Access Compliance Report

Public Rights-of-Way

(Curb Ramps)

Intersection ID: 32317	Main Street: BRIDGEVIEW_LN	Cross Street: NEW_PROVIDENCE_LN	Location: E
ADA ID: 9B6225756ABA	Ramp Type: PerpDiag	Initial Pass/Fail: Fail	Overall Compliance: No
		Severity Score: 37.5

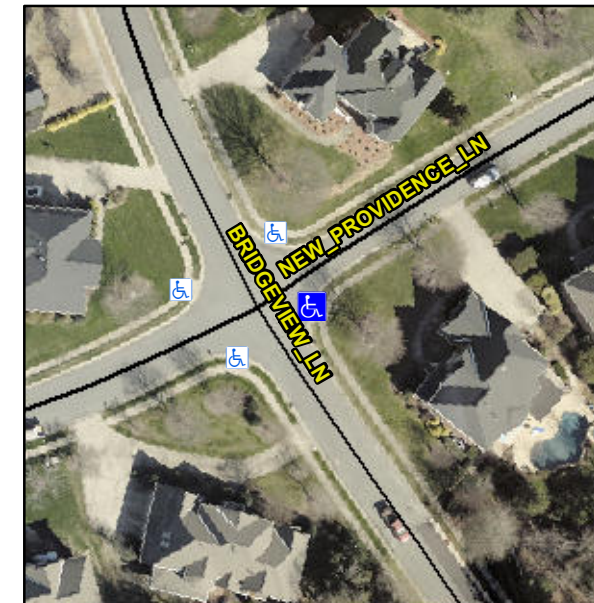
Not Found, R304.2.2, R304.5.3

Compliance	Description	Data	Compliance	Description	Data
N/A	Ramp Length (in)	46.5	No	Ramp Slope (%)	8.7
Yes	Ramp Width (in)	48.0	No	Ramp XSlope (%)	9.0
N/A	Flare Type LT	N/A	N/A	Flare Type RT	N/A
N/A	Flare Slope LT (%)	N/A	N/A	Flare Slope RT (%)	N/A
N/A	Flare Traversable LT?	N/A	N/A	Flare Traversable RT?	N/A
N/A	Landing Length (in)	N/A	N/A	DWS Provided?	N/A
N/A	Landing Width (in)	N/A	N/A	DWS Contrast?	N/A
N/A	Landing Slope (%)	N/A	N/A	DWS Length (in)	N/A
N/A	Landing X Slope (%)	N/A	N/A	DWS Full Width?	N/A
N/A	Landing Curb? (Y/N)	N/A	N/A	DWS Offset (in)	N/A
N/A	Shared Landing?	N/A			
N/A	Gutter Ponding?	N/A	N/A	Gutter Slope (%)	N/A
N/A	Gutter Lip Ht (in)	N/A	N/A	Gutter X Slope (%)	N/A
N/A	Painted X Walk1?	No	N/A	Painted X Walk2?	No
	X Walk 1 Direction	To NW		X Walk 2 Direction	To SW
N/A	X Walk 1 Width (in)	N/A	N/A	X Walk 2 Width (in)	N/A
	X Walk 1 Slope (%)	5.5		X Walk 2 Slope (%)	0.9
	X Walk 1 X Slope (%)	2.6		X Walk 2 X Slope (%)	7.4

Remove & Replace Curb Ramp With Two New Directional Ramps or Equivalent.
